341 Bella Vista Avenue

SUMMARY OF MITIGATION MEASURES AND MONITORING PROGRAM FOR THE 341 BELLA VISTA AVENUE PROJECT

PUBLIC COMMENTS AND RESPONSES REGARDING

Index to Response to Comments

Attachment 1

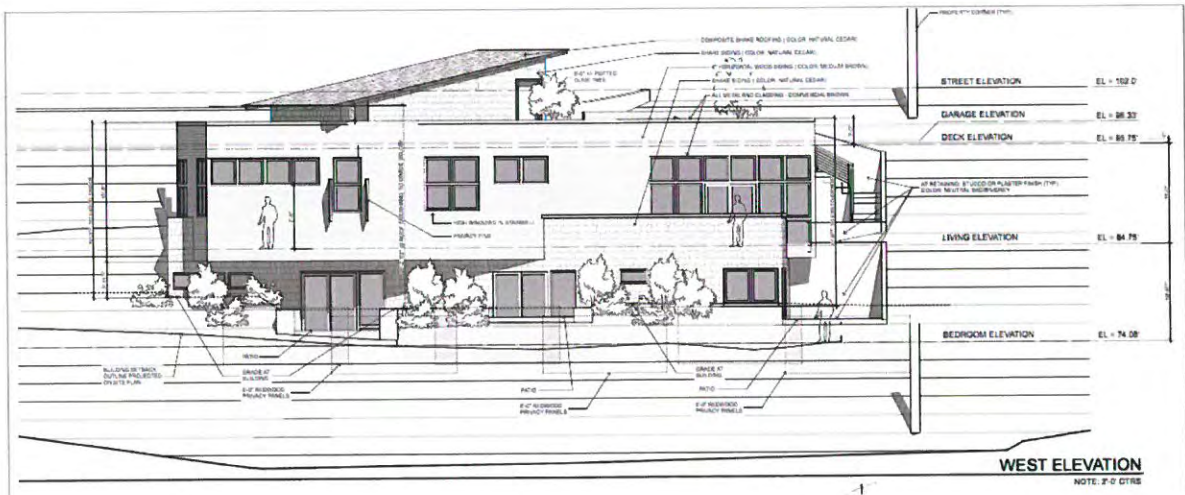
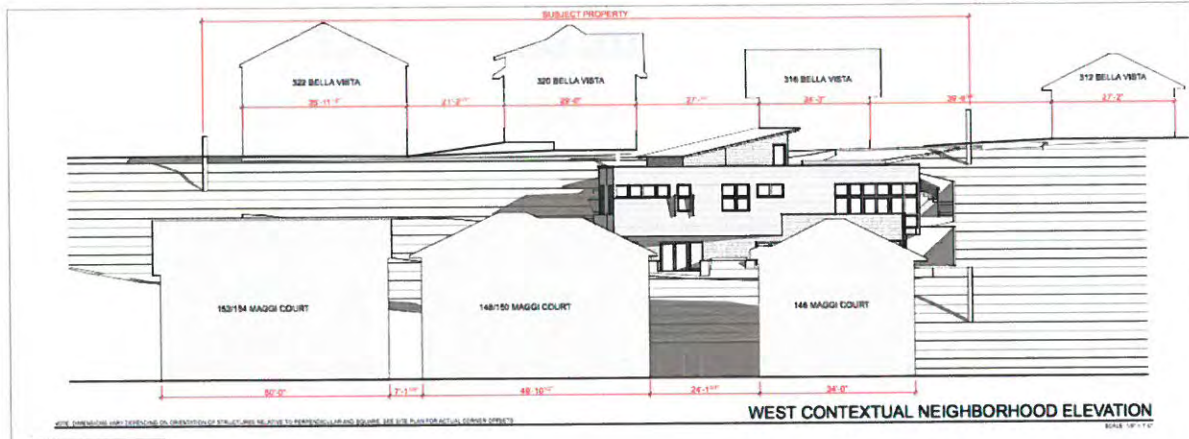
Building to replace two 150 year old oak trees and a natural, rural, woodland setting, and to be only forty seven feet away from my backdoor.

- A-13 Attachment 1. Please see response A-3 regarding the preservation and replacement of trees on the project site. The project would comply with the Town Code for required setbacks on all sides of the property. The building is setback 22 feet and 3 inches from the edge of the western property line. The nearest building on Maggi Court is 48 feet from the nearest edge of the proposed house. It should be noted that 48 feet is approximately double the distance of separation of any of the adjacent homes on Maggi Court or Bella Vista Avenue.

Attachment 3 - Santa Clara County Geologic Hazards Map (from sccgov.org website, most recent)

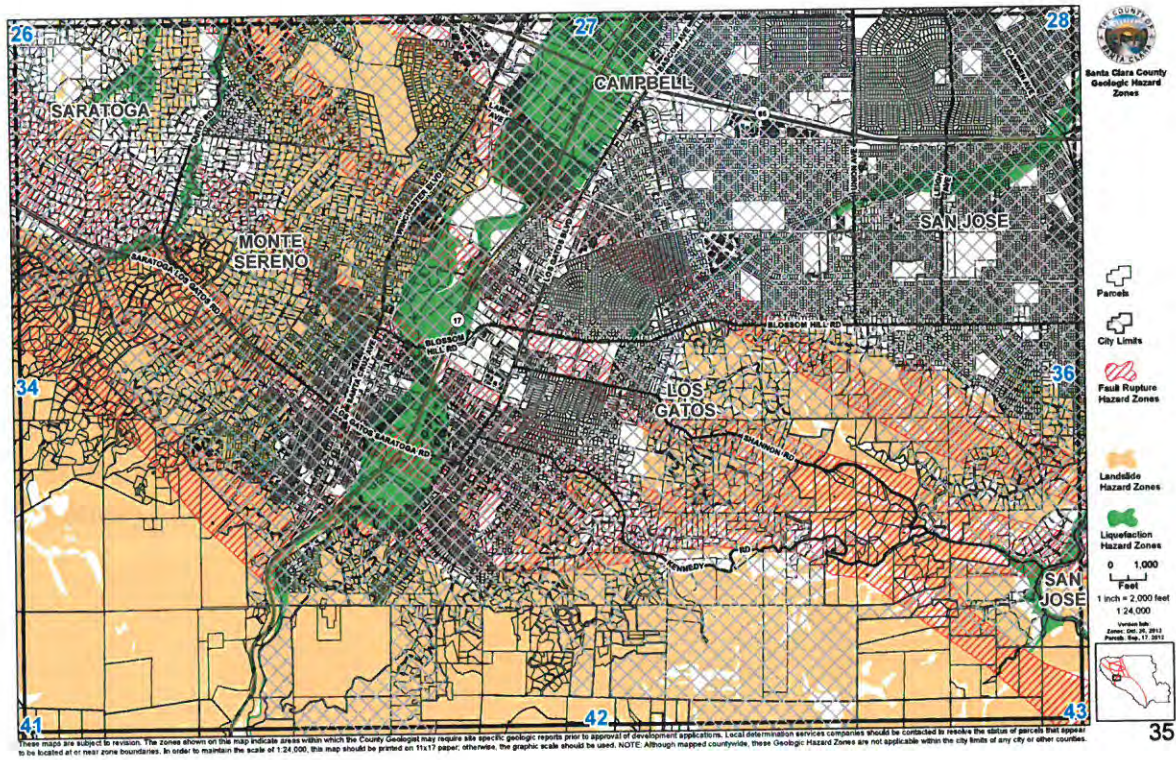
Showing (may have to zoom in) that the project is located in a 'perfect storm' of geological hazards - risk of landslide on the hillside, risk of liquefaction in the town homes and all of it very close to a fault zone.

- A-14 Attachment 2. Please see Response A-6 regarding the Tree Preservation Ordinance.
- A-15 Attachment 3. Please see Responses A-7 and A-8.
